Access Compliance Report Public Rights-of-Way (Curb Ramps)

Main Street: HEWES_ST Cross Street: E_ORANGE_GROVE_AVE Location: NE

ADA ID: RPAT211020084324 Ramp Type: Type 1 - Perpendicular Diagonal Initial Pass/Fail: Pass Overall Compliance: No Severity Score: 0

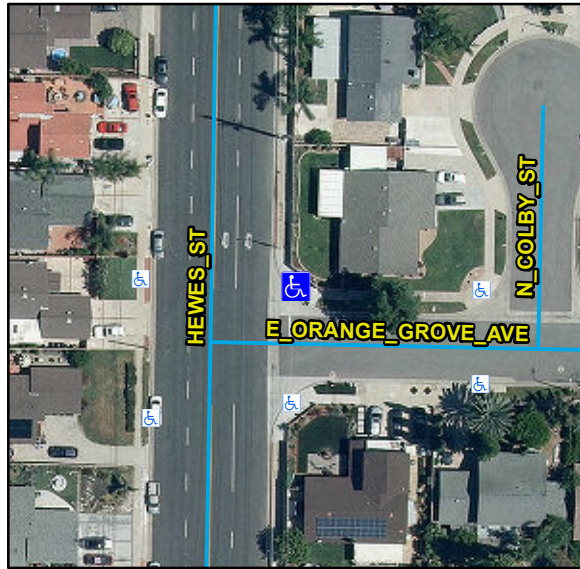
Remove & Replace Curb Ramp With Two New Directional Ramps or Equivalent.

R304.2.2, R304.2.1, STD 1115
